MILITARY SPECIFICATION SHEET

FILTER, BAND PASS, TYPE FR4QX22YY1

This amendment forms a part of Military Specification Sheet MIL-F-18327/29A, dated 19 June 1970, and is approved for use by all Departments and Agencies of the Department of Defense.

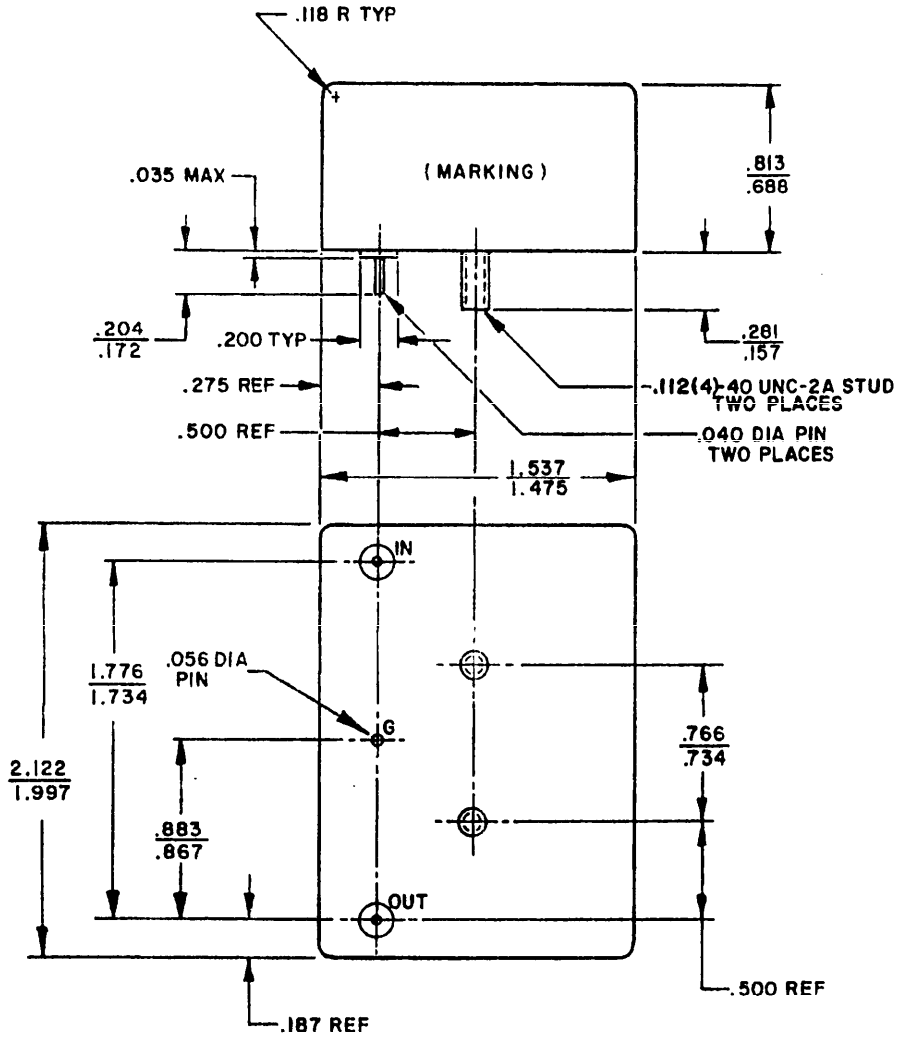
FIGURE 1: Delete and substitute the following new figure.

* Requirements, Terminals: Delete "pin." and substitute "Solderable pin (see figure)."
